Town of East Lyme

December 26, 2023

RE: Petrit Subdivision – 220 Pennsylvania Ave

The Engineering department Has reviewed the Petrit Marku subdivision at 220 Pennsylvania Avenue with a revision date of 12-3-23.

SIDEWALK DETAIL

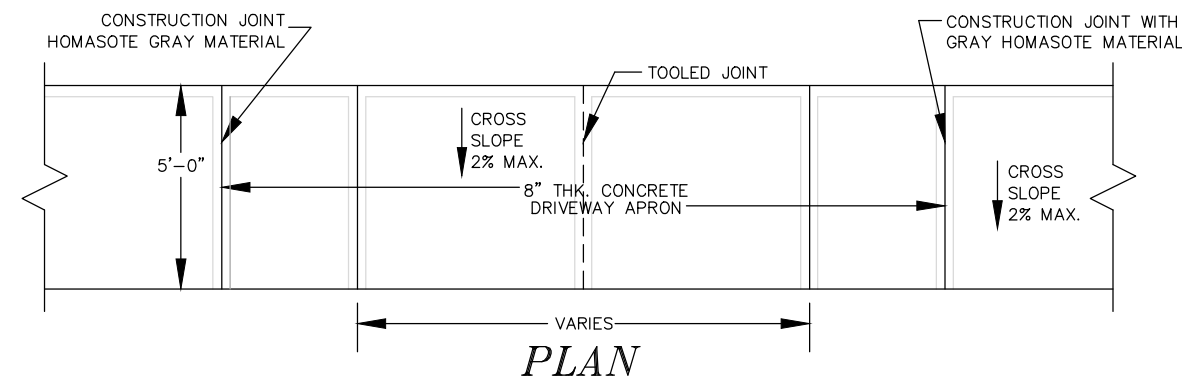
1. The Town of East Lyme owns and maintains the sidewalks at this location in the State of Connecticut Right-of-Way (ROW). Our Town standard requires the sidewalk to go through the driveways and be 8" thick in the driveway as shown on the attached detail. Even though there is an existing sidewalk, it will need to be removed and replaced with sidewalks constructed to Town standard crossing the new driveways. The sidewalk that is currently there will not be able to handle the vehicle traffic over it. The sidewalk that goes through the existing driveway will need to be reconstructed and raised according to the Town standard, when that driveway is removed. The sidewalk, at its current elevation will create a low spot and a puddle when the asphalt curbing on the State Road is re-installed. No tactile warning strips are required at this location. These items shall be called out on the subdivision plan and the Town standard details shall replace the sidewalk details in the plan set.

- NOTES:
1. FINISH: BROOM FINISH PERPENDICULAR TO TRAFFIC AND WITH PICTURE FRAME EDGES.
 2. SIDEWALK TO BE 5" THICK WITH 6X6 - 10/10 WWF.
 3. USE 4,400 PSI, CLASS F CONCRETE.
